STAFF REPORT

TO: Committee of the Whole **MEETING DATE:** September 26, 2023
FROM: Planner II **FILE NO:** 3220-Marine Dr-458
SUBJECT: Form and Character Development Permit (DP-2022-33), Development
Variance Permit (DVP-2022-09), and Flood Exemption (DVP-2022-08) for a
proposed mixed-use commercial and 9-unit residential building at 458
Marine Drive.

Figure 3: Seawalk (east) elevation

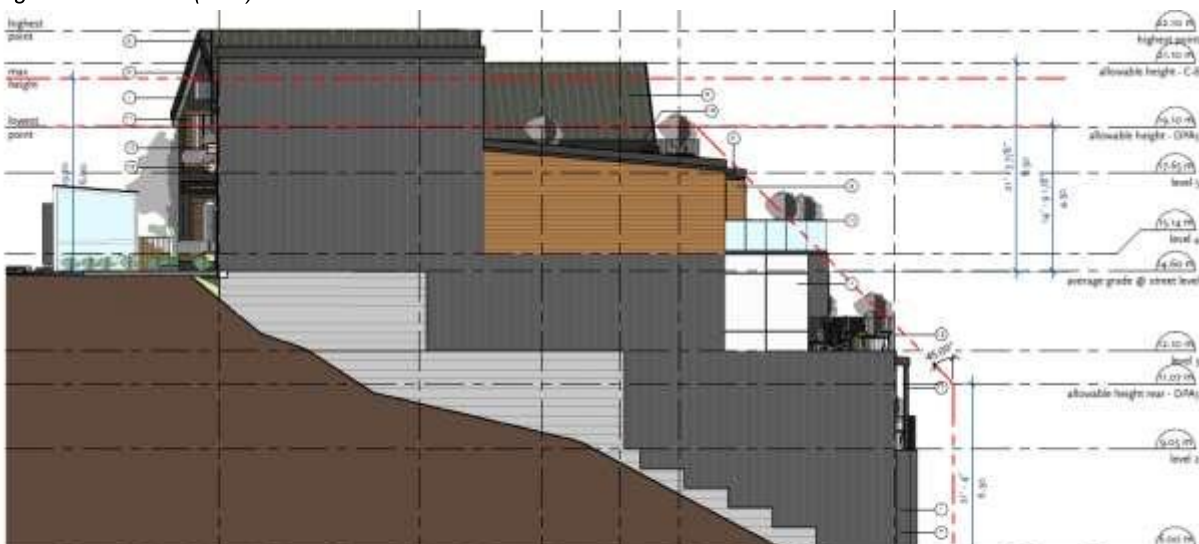
1. *Landscaping on the seaward side has the opportunity to include soft armouring and reduce the visibility of the concrete retaining wall at the base of the building*
1. *Colour scheme for the building and roof be lighter to reduce heat absorption and more*
2. *lively natural colours*
3. *Bus stop be situated so that there's less impact to accessibility on the sidewalk*

4. *Visual and safety of the pad mounted hydro box on the sidewalk be reviewed, perhaps with collaboration with a local artist*
5. *Consider landscaping the North Side 3-metre right-of-way and provide pedestrian access to the seawalk by way of stairs*
6. *Incorporate commercial signage into the design for Council consideration*
7. *Remove trees from renderings that would be lost in construction*
8. *Parking garage elevator to have a warning light/sound system installed to warn pedestrians and traffic of a vehicle exiting the lift*

The applicant submitted revised drawings, enclosed as Attachment A reflecting the ADPs comments, and included the following:

- Lighter metal siding colour
- Lighter trim colour
- More white stucco panels on all elevations
- wrapping the material around the elevations
- Added the retail sign with lights above
- Added the address number with a light above
- Changed PMT (hydro box) look (a placeholder for the local artists)
- Added a sign above the parking door and change the driveway path
- Added horizontal texture to the waterside retaining wall at the bottom
- Added the note on the utility easement: "Landscaping TBD, pending Town of Gibsons Infrastructure approval."
- Added a roof and bench to the bus stop

Figure 5: Regulations for sub area D

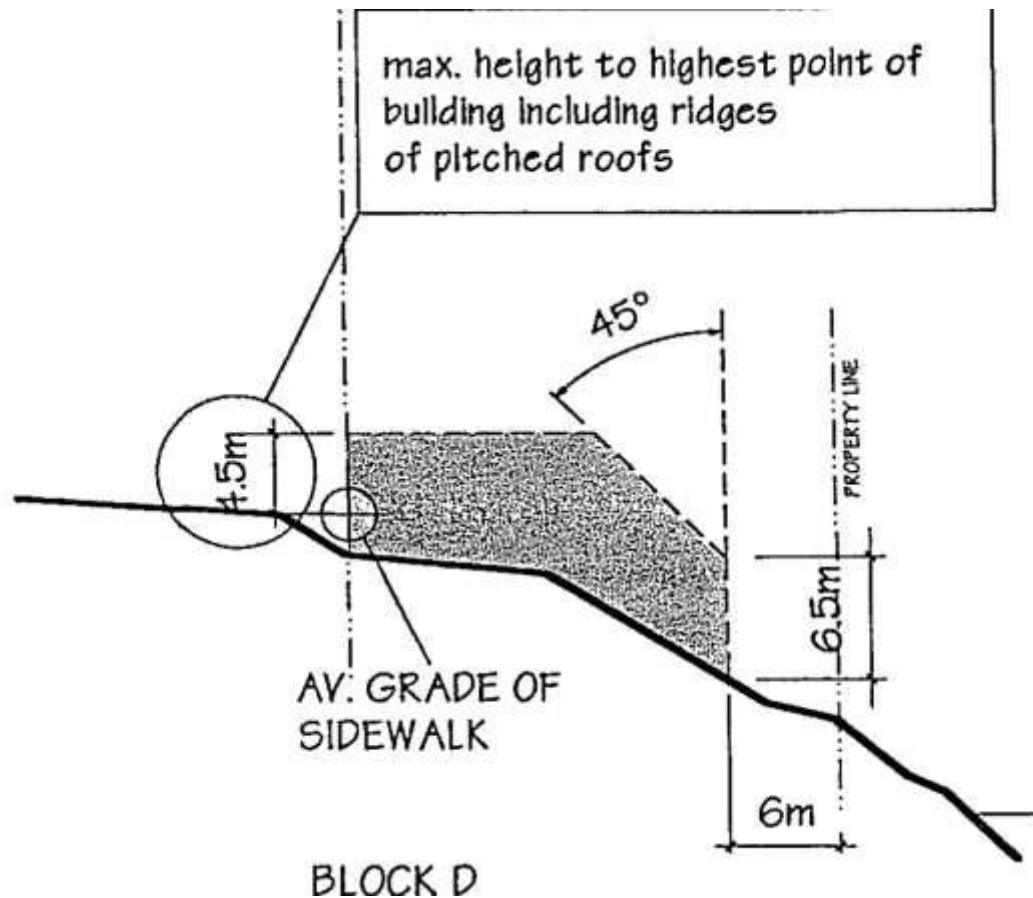
The regulations in Part 5-View Protection of the Zoning Bylaw supersede the building height and setback regulations of the C-8 zone, and therefore the property has a building height limit of 4.5m from the average natural grade of the Marine Drive sidewalk to the highest point of the building, as shown in Figure 5.

This building height measurement is more restrictive than the rest of the Zoning Bylaw, where building height is measured to the midpoint of a pitched roof.

The applicants are requesting a 3 m height increase variance from the average grade of the sidewalk to allow a building height of 7.5 m (2-storeys) at Marine Drive.
